## PLAN REVIEW RESPONSE

JLG 18126 Eastgate Apartments

Date: September 21, 2020

## ALTERNATE DESIGN METHOD

**TYPICAL ENLARGED PLAN DETAIL AT 2<sup>ND</sup> LEVEL (similar at other floors)**

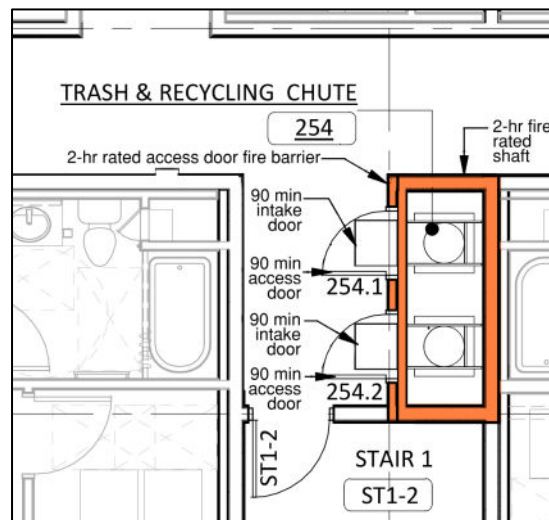
### 2. Code Section applying for Alternate Design Method: 2018 IBC Section 713.13.3 Chute Access Rooms

- Access openings for waste or linen chutes shall be located in rooms or compartments enclosed by not less than 1-hour fire barriers constructed in accordance with Section 707 or horizontal assemblies constructed in accordance with Section 711, or both. Openings into the access rooms shall be protected by opening protectives having a fire protection rating of not less than  $\frac{3}{4}$  hour. Doors shall be self- or automatic-closing upon the detection of smoke in accordance with Section 716.2.6.6. The room or compartment shall be configured to allow the access door to the room or compartment to close and latch with the access panel to the refuse or laundry chute in any position.

- At trash and recycling chute locations, provide a 2-hr fire barrier that is separate from the 2-hr fire rated shaft as required per 2018 IBC Section 713.13.2 in lieu of a chute access room with 1-hr fire barrier.
- At each location, provide two (2) 90-minute fire rated access doors within the 2-hr fire barrier at the chute intake doors.
- Refer to the enclosed Trash Chute Submittal from the Contractor that is to be installed which includes 90-minute fire rated intake doors at the 2-hr fire rated shaft as required by 2018 IBC Section 716 (see Material Listing Item #2)
- Refer to the Enlarged Plan Detail below that illustrates the separate enhanced protection for the trash chute openings that exceeds the minimum fire rating code requirements outlined in 2018 IBC Section 713.13.3 Chute Access Rooms.

- The proposed 2-hr rated fire barrier design provides a higher level of protection than the 1-hr rated fire barrier that is required for a trash chute room per 2018 IBC Section 713.13.3.
- Two (2) 90-minute fire rated doors provide a higher level of protection at each intake chute compared to a single 45-minute fire rated door that is required for a trash chute room per 2018 IBC Section 713.13.3
- The other components of the trash and recycling chute as designed meets all other code requirements for waste chutes.
